# Tiva™ C Series TM4C129x Microcontrollers Silicon Revisions 1, 2, and 3

## Silicon Errata

Literature Number: SPMZ850D  
October 2013–Revised March 2015

**ETH#04**                      ***SMI Electrical Section Update (1)***
**Revision(s) Affected:**    1, 2, and 3.

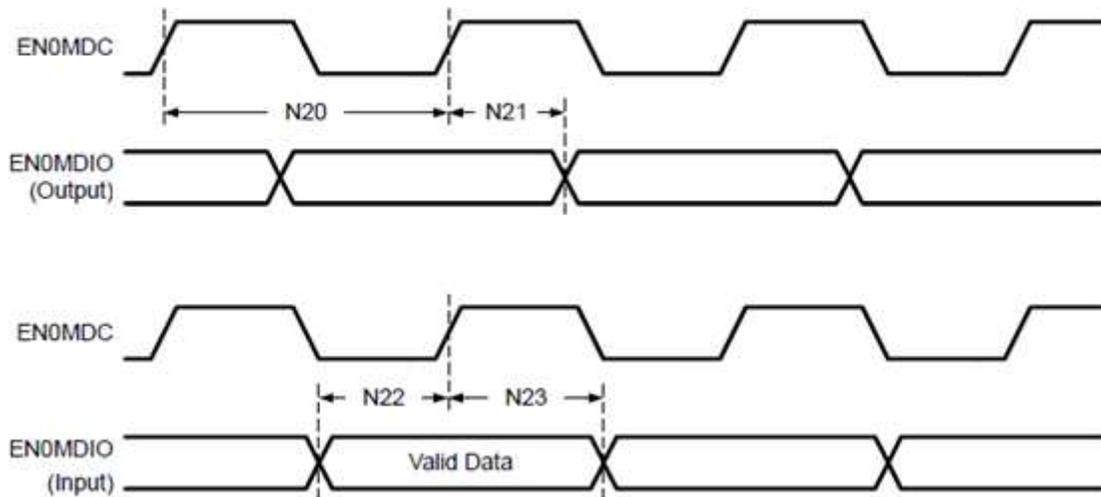
**Description:**                The following table in the Electrical Characteristics for Ethernet Controller AC Characteristics for MII Serial Management the table is incorrect for parameters N20 and N21.

Parameter No.	Parameter	Parameter Name	Min	Nom	Max	Unit
N20	F <sub>MDC</sub>	ENOMDC frequency	-	-	2.5	MHz
N21	T <sub>MDO_DLY</sub>	ENOMDC to ENOMDIO (output) delay time	0	-	150	ns
N22	T <sub>MDO_SU</sub>	ENOMDIO (input) to ENOMDC setup time	10	-	-	ns
N23	T <sub>MDO_HLD</sub>	ENOMDIO (input) to ENOMDC hold time	10	-	-	ns

The MDO Timing =  $(1/(2 \cdot F_{MDC})) + 1 \text{ System Clock Period} + 10\text{ns}$

**Figure 3. VDDA Waveform to Avoid Between  $V_{POR}$  min and  $V_{POR}$  max**

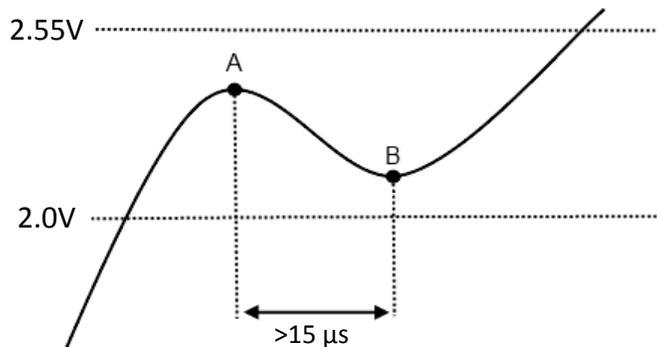
**Workaround(s):** A monotonic voltage rise of VDDA prevents this issue from occurring; however, a perfect monotonic ramp is difficult to achieve, particularly during LDO inrush. The risk of encountering this issue can be minimized by performing one of the following:

- If the VDD and VDDA pins are connected directly to the same power source, at every possible point A and point B along the VDDA waveform between 2.0 V and 2.55 V, point B must never fall below point A after 15  $\mu$ s, as shown in [Figure 3](#).
- Use a separate power supply for VDDA to reduce noise and isolate it from the effects of LDO inrush. At every possible point A and point B along the VDDA waveform between 2.0 V and 2.55 V, point B must never fall below point A after 15  $\mu$ s, as shown in [Figure 3](#). The separate power supply will make it easier to avoid this condition.
